Re: Sunroom Addition
479 D.L. Phillips Lane
Broadway, North Carolina

OTG Consulting, PLLC (OTG) was requested to evaluate the design change for the sunroom addition. We understand that an original structural design was performed by Line on Design, dated April 14, 2023. OTG was requested to review the provided value-engineered design performed by you.

SUNROOM CROSS SECTION DETAIL

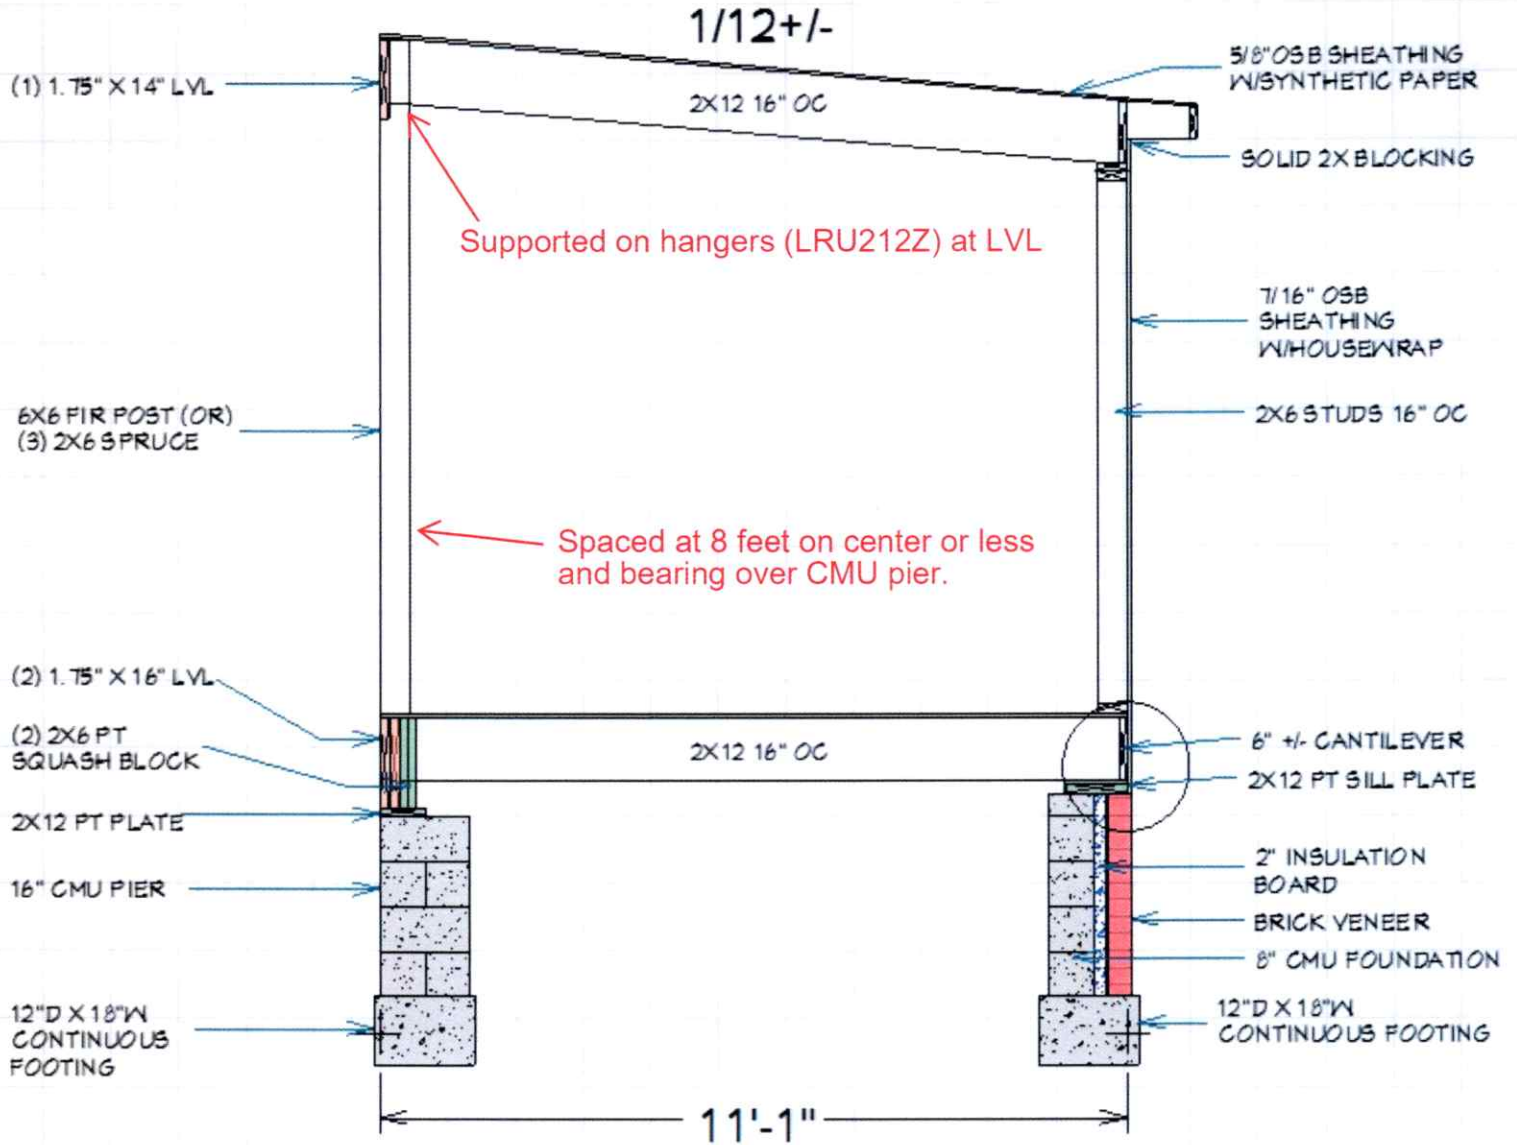
The sunroom measures approximately 11'-1" by 29'-8" and will be supported by a shallow foundation system. OTG was provided with a typical cross section detail indicating roof framing, wall framing, and floor framing details. In addition, OTG was provided a plan drawing indicating floor framing layout/spacing as well as overall dimensions. Floor joists for the sunroom are planned to be 2x12 dimensional lumber spaced at 16 inches on-center. The joists will bear on a 2-ply LVL (1-3/4" x 16") band joist adjacent to the house and supported on 16-inch CMU foundation piers. On the opposite wall, the joists will bear on an 8-inch CMU foundation pier, 2-inch insulation board, and brick veneer.

The back wall, away from the house, will be framed with 2x6 studs at 16 inches on-center and 7/16" OSB sheathing. The front wall, adjacent to the house will be supported by either 6x6 fir posts or (3) 2x6 SPF posts. The roof joists will consist of 2x12 spanning approximately 11'-1" and spaced at 16 inches on center. A single-ply LVL (1-3/4" x 14") will be used to support the roof joists at the house with the joists bearing on the 2x6 wall with solid 2x blocking on the opposite wall. The roof will have a 1:12 slope and metal panel roofing with 5/8" OSB sheathing.

Based on our review of the value-engineered design, the plans are sufficient to support the loads and are in compliance with NC Residential Building Code. OTG recommends that the 6x6 post or (3) 2x6 SPF posts be spaced no more than 8 feet apart and located on a CMU pier for proper load path to the foundation.
